THE CLEVELAND ELECTRIC ILLUMINATING COMPANY

April 19, 1982

Perry Nuclear Power Plant
Docket Nos. 50-440; 50-441
Structural Engineering Branch

In a meeting with the Structural Engineering Branch from December 1-4, 1981, several action items were identified. This letter forwards responses for two of those action items.

FIGURE 23-1 OFF-GAS BUILDING-FRS COMPARISONS
ROOF OF STRUCTURE ELEV. 660'-0"

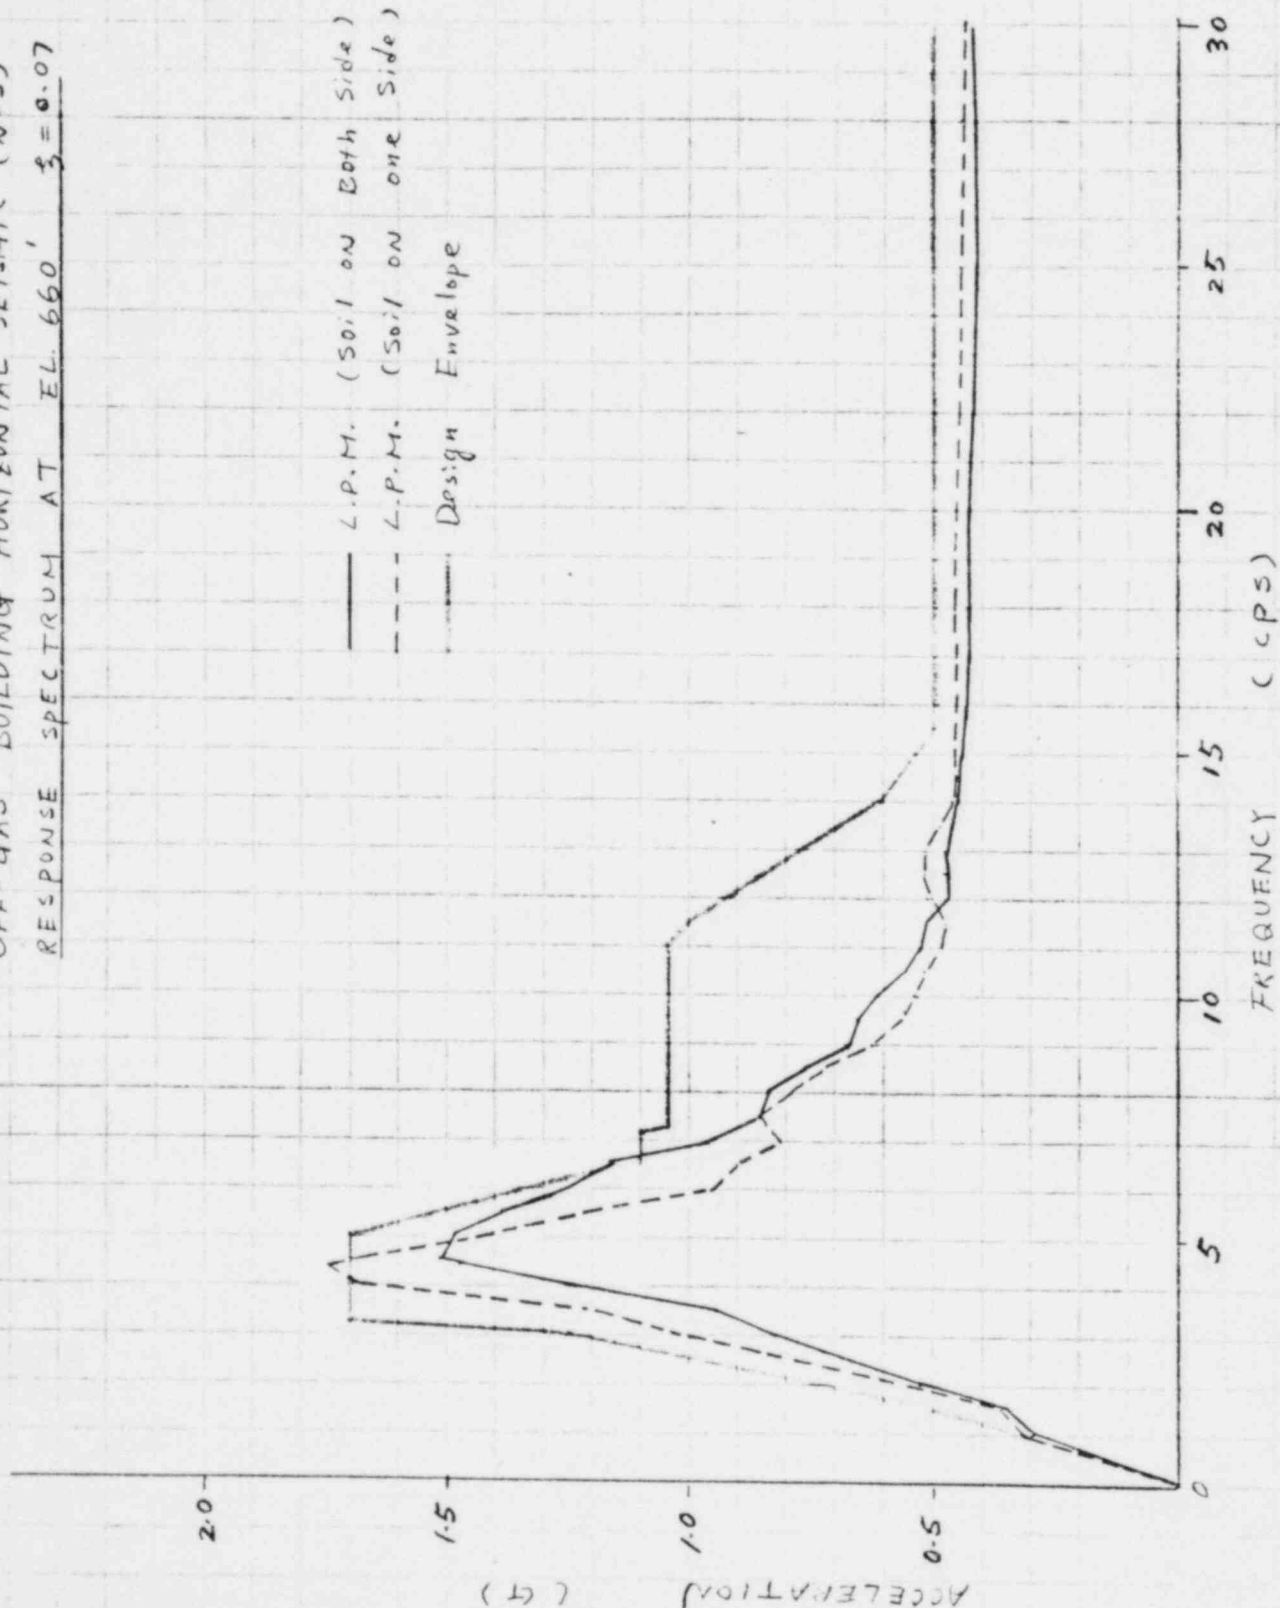
THE FOLLOWING 4 FIGURES, 23-1, 23-2, 23-3 AND 23-4 SHOW THE COMPARISONS OF:

AS CAN BE SEEN, THE LPM RESULTS ARE ENVELOPED BY THE DESIGN SPECTRA. THE LPM RESULTS TEND TO BE NARROW BANDED, DUE TO THE AVAILABILITY OF SINGLE DOMINANT MODES, IN THIS CASE THE ROCKING MODE. THE FINITE ELEMENT MODEL TENDS TO HAVE MORE OF A BROADER BANDED COMPOSITION.

FIGURE 23-5 DIESEL GENERATOR BUILDING
ROOF LEVEL - EL. 602.1-6"

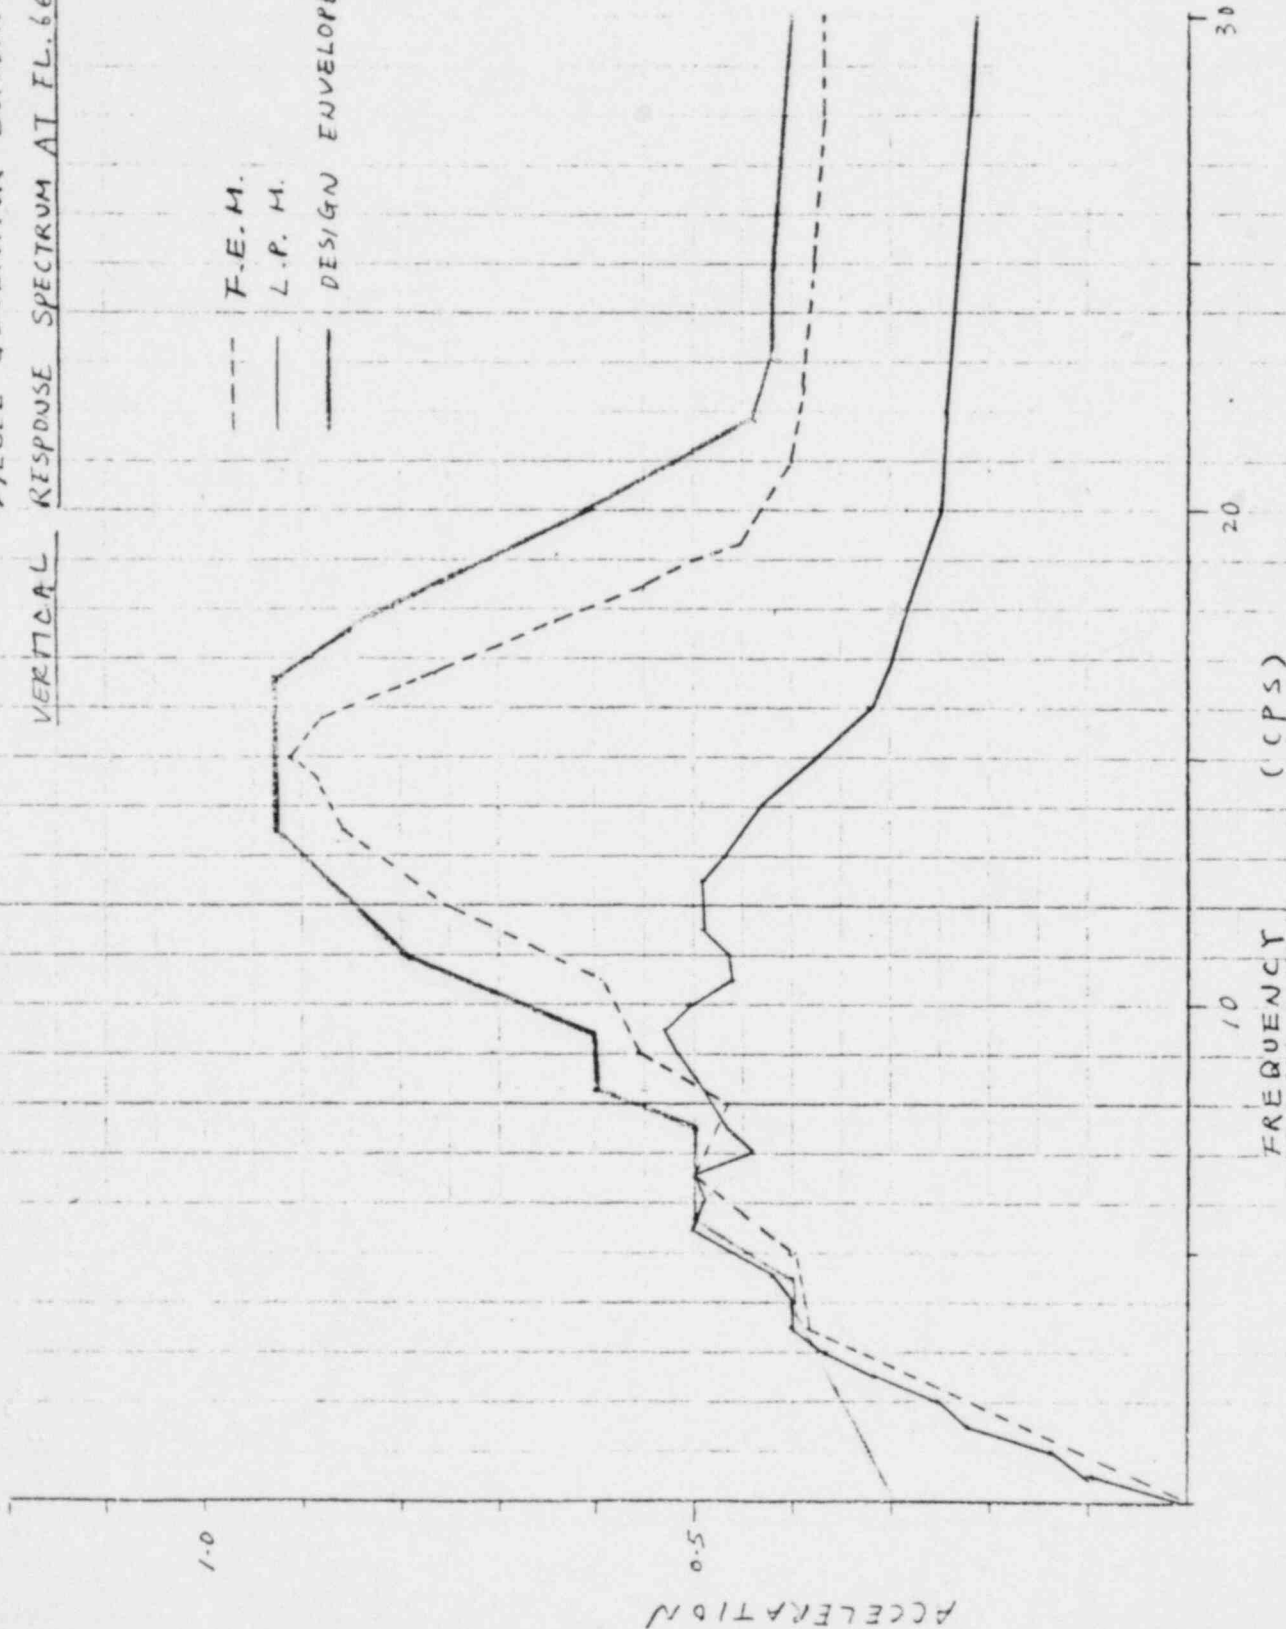
FIGURES 23-5 AND 23-6 SHOW RESULTANT FLOOR RESPONSE SPECTRA, COMPARED WITH CORRESPONDING FLOOR RESPONSE SPECTRA OBTAINED FROM THE FINITE ELEMENT ANALYSIS. ALSO PLOTTED IS THE DESIGN FLOOR RESPONSE SPECTRA USED IN SUBSEQUENT SEISMIC QUALIFICATION.

THE LPM ANALYSIS PREDICTS RESULTS SIGNIFICANTLY LESS THAN THE FINITE ELEMENT METHOD, FOR THE DIESEL GENERATOR BUILDING.
